FCC Class II Permissive Change Request Letter

RE: FCC Permissive II Change Request for Company: Anker Innovations Limited FCC ID: 2AOKB-A1685

Serial number	Original	New
1		
2

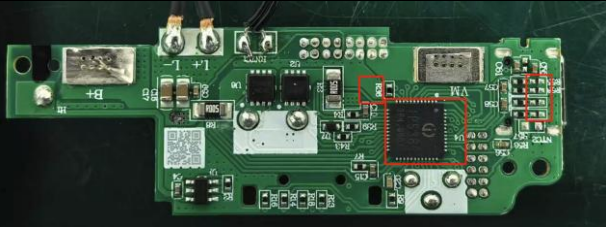
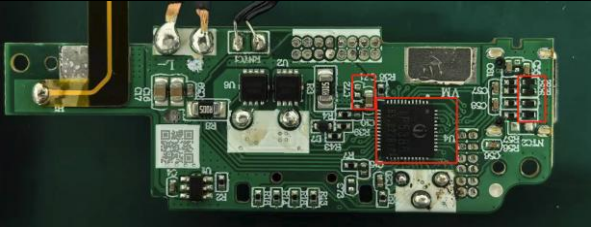
1. Change the IC(U4)(New IC model: IP5385P).
2. Add TVS and capacitor components.
